Central Planning Authority

Minutes of a meeting of the Central Planning Authority held on August 04, 2021 at 10:00Am, in Conference Room 1038, 1st Floor, Government Administration Building, Elgin Avenue.

CPA/16/21

Figure 1. The purple band shows the area of mangroves and the blue shows Vulgunner's Pond.

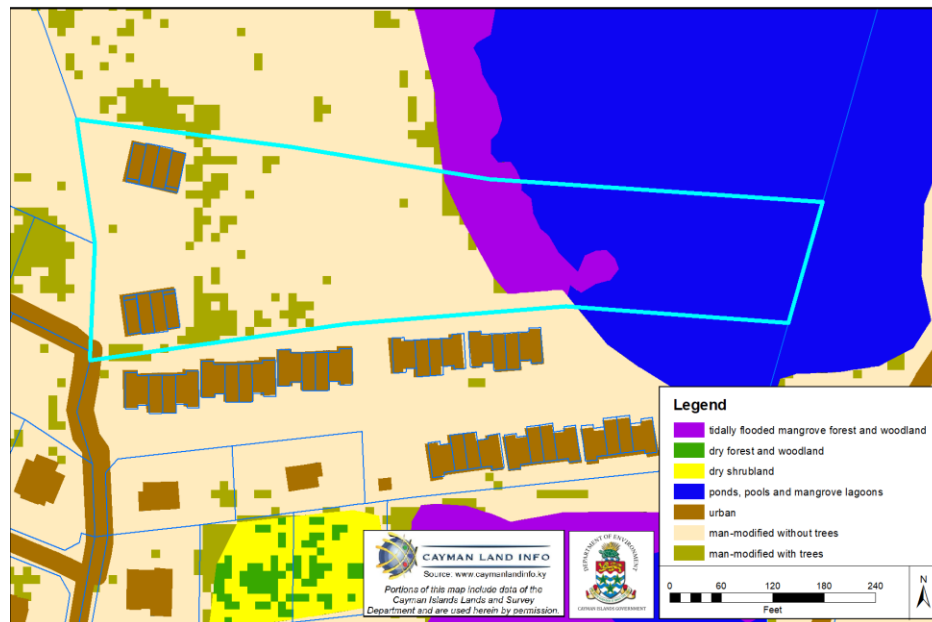
The site is man-modified except for the part of the site within Vulgunner's Pond and approximately 120 feet of tidally flooded mangrove forest adjacent to the pond (Figure 1). Vulgunner's Pond is a natural pond. It has been impacted by development in the area, but is habitat for birds and waterfowl (Part 1 Schedule 1 species under the National Conservation Act).

Figure 2. A 50 ft mangrove buffer was retained at the property to the south.

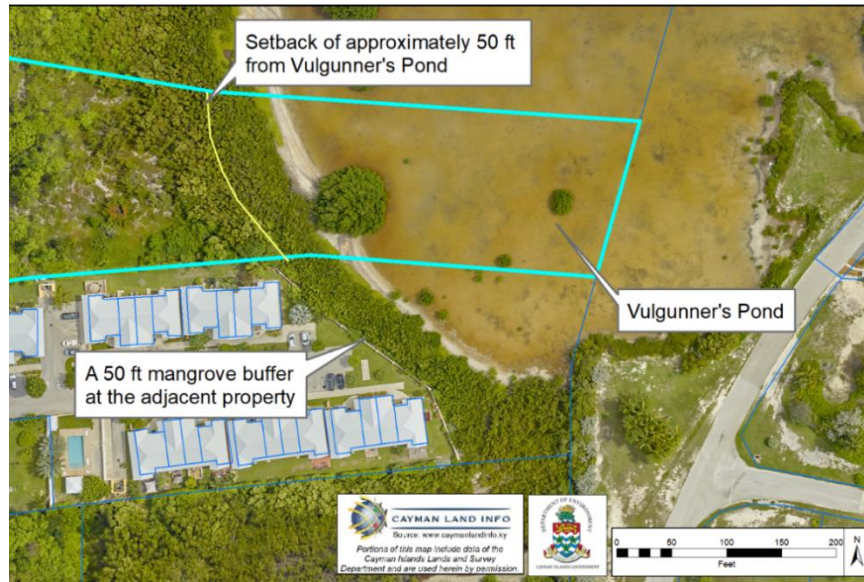
When the development adjacent to the south was constructed, a 50 ft buffer of mangroves next to Vulgunner's Pond was retained (Figure 2).

Figure 3. An excerpt of the planning application and an approximately 50 ft mangrove buffer (yellow).

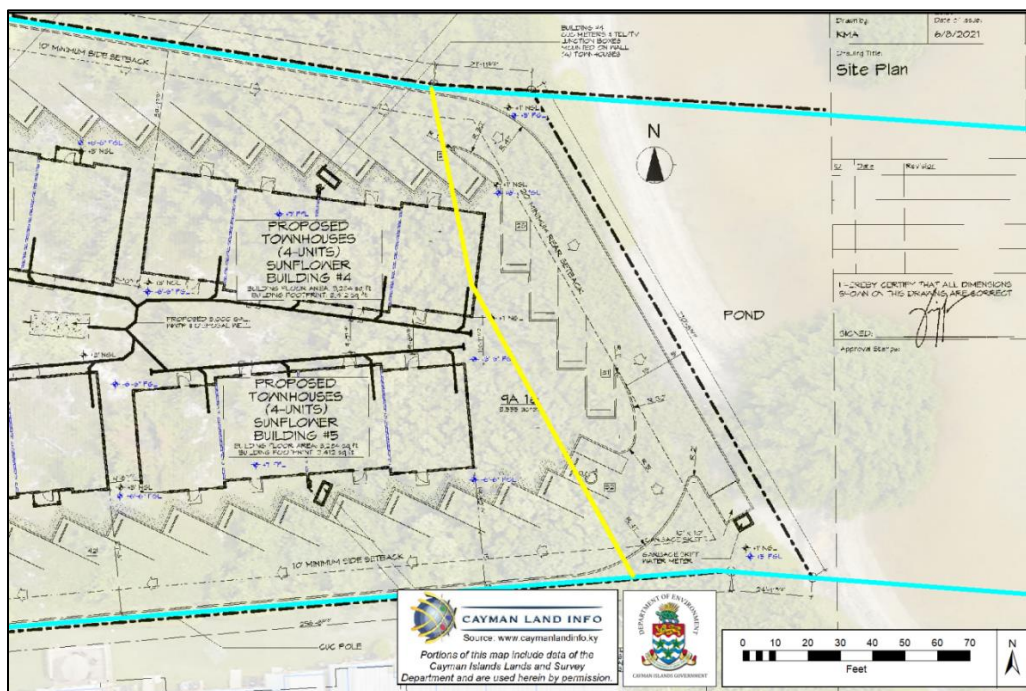
We recommend that this development also retains a 50 ft buffer of mangroves to separate it from Vulgunner's Pond. Figure 3 shows an excerpt of the planning application drawings and an approximately 50 ft buffer.

Retaining a 50 ft buffer of mangroves would help to prevent runoff from the development going into Vulgunner's Pond, which can affect water quality. It would also aid in protection against flooding. It would provide habitat along the water's edge for birds and other wildlife.

Figure 2: LIS Terrain Model showing site elevations including the natural ridge

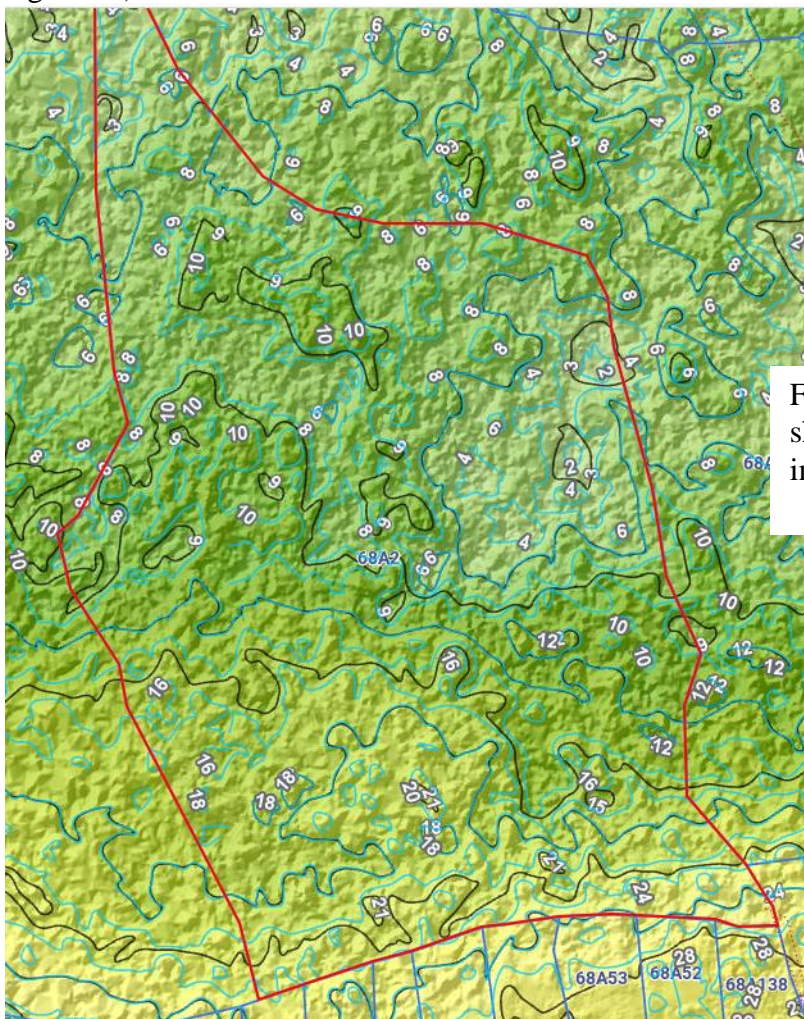
From a review of the historical aerial images of this site, it appears that in 1958 the land may have been partially used/cleared for agricultural purposes. There is an area along the western boundary which has been undisturbed and is primary habitat consisting of dry forest and shrubland (see Figure 1a and 1b). As you can see from Figure 1b, the site has re-vegetated over the years and currently consists of ecological valuable secondary growth, with areas of primary dry forest and shrubland habitat. The application site is immediately to the south of a Crown-owned parcel (67A19) that is of environmental significance. The Crown parcel has been identified as worthy of protection and is proposed as a protected area. The application site also has a natural elevated ridge, as shown in Figure 2.

The Department questions the need for more residential subdivisions without an updated Development Plan. The current Development Plan is outdated and does not reflect accurately how the island should be developed moving forward taking into consideration the population size, projected population growth, the environment and climate change. Thus without an updated development plan for the islands there is no vision on how the island should progress in terms of development. This can result in unnecessary fragmentation of ecological valuable habitats and loss of valuable limited resources (such as land and associated ecosystem services). It is recommended that prior to approval of this subdivision, the supply and demand of residential lots should be determined as there has been other large scale subdivisions that have been recently granted approval and remain undeveloped. This often results in adverse effects on the environment now if the land is cleared, with homes not being constructed for years (sometimes decades).

*Figure 1: LIS 2018 Aerial Imagery Showing Application Parcel (Outlined in Blue)
Please do not hesitate to contact the Department should you require further assistance.*

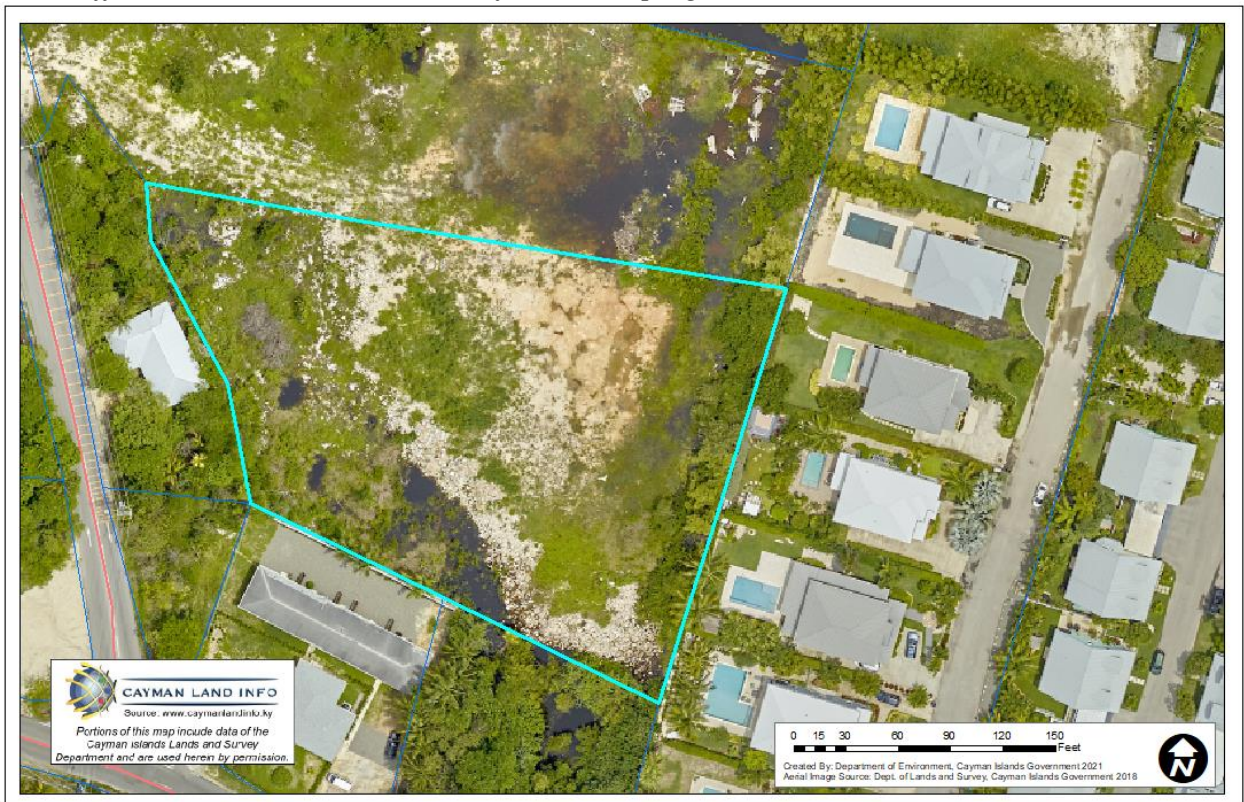
The application site is man-modified but was previously part of seasonally flooded Mangrove wetland habitat. The site is low lying and therefore it is recommended that a stormwater management plan is developed to ensure that any site derived storm water runoff is handled on site and does not impact surrounding areas. It is also recommended that native vegetation is incorporated into the landscaping scheme. Native vegetation is best suited for the habitat conditions of the site, requiring less maintenance and making it a cost effective and sustainable choice for landscaping.

Figure 4. The proposed development georeferenced to Lands and Survey data with the 2018 aerial imagery.

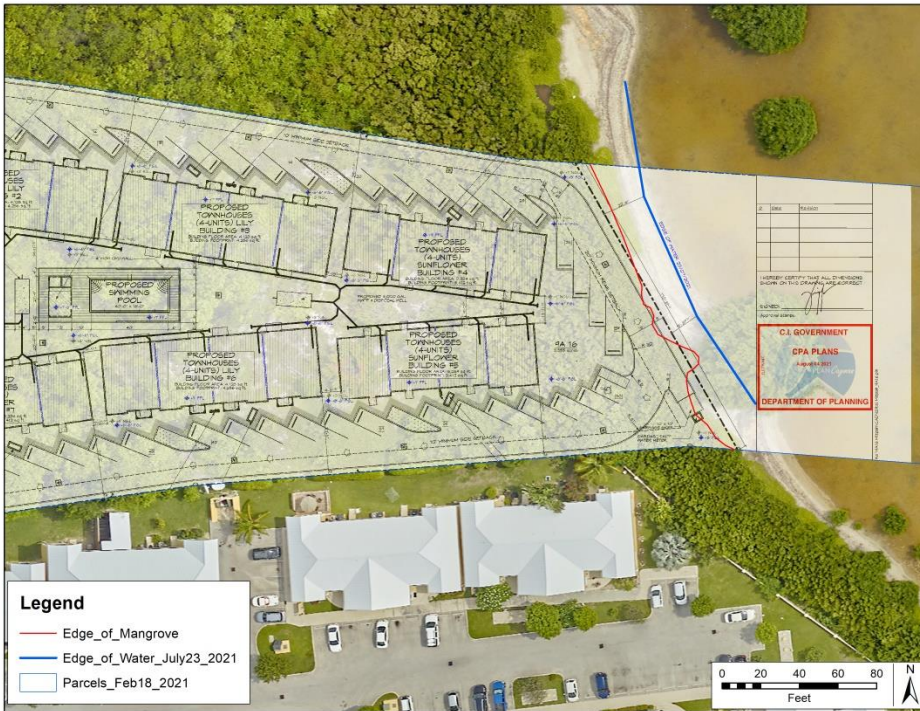
The site is man-modified except for the part of the site within Vulgunner's Pond and approximately 120 feet of tidally flooded mangrove forest (see Figures 2 to 5). As stated above, mangroves are Part 2 Schedule 1 protected species under the National Conservation Act with a Species Conservation Plan in force. Vulgunner's Pond is a natural pond. It has been impacted by development in the area, including dredging, but remains habitat for birds and waterfowl (Part 1 Schedule 1 protected species under the National Conservation Act, which means they are protected at all times). The pond does have ecological value.

Figure 6. The updated plans, showing a mangrove buffer of 50 ft, which is in line with the development to the south.

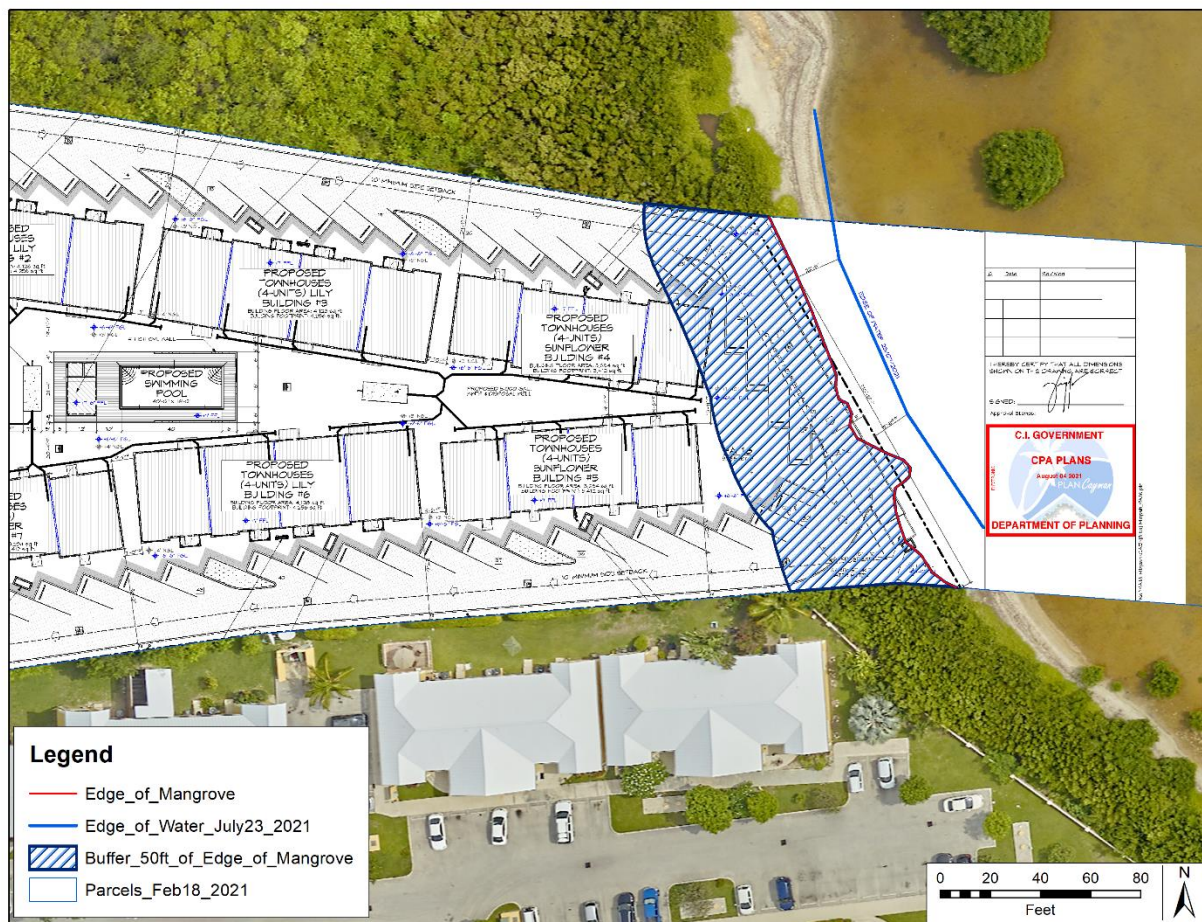
The Department supports the applicant's retention of Vulgunner's Pond and agrees that it will be a valuable feature of part of the development. We agree that the pond has natural beauty and that the wildlife of the pond can become a feature of the development itself. We also do appreciate that more of the site falls within Vulgunner's Pond than the development to the south, and therefore retention of Vulgunner's Pond means that the Applicant will be leaving more of their site undeveloped than the development to the south did. We agree that leaving the mangrove 'island' will provide a habitat for birds.

We also maintain that leaving more mangroves along the water's edge would leave more habitat for birds and other wildlife, and prevent degradation of the pond from the development. We continue to recommend that in addition to retaining the pond itself, a 50 ft mangrove buffer is retained around Vulgunner's Pond. When the development adjacent to the south was constructed, a 50 ft buffer of mangroves next to Vulgunner's Pond was retained (Figure 6). Therefore, we maintain that including a 50 ft buffer of mangroves would be in keeping with the surrounding area.
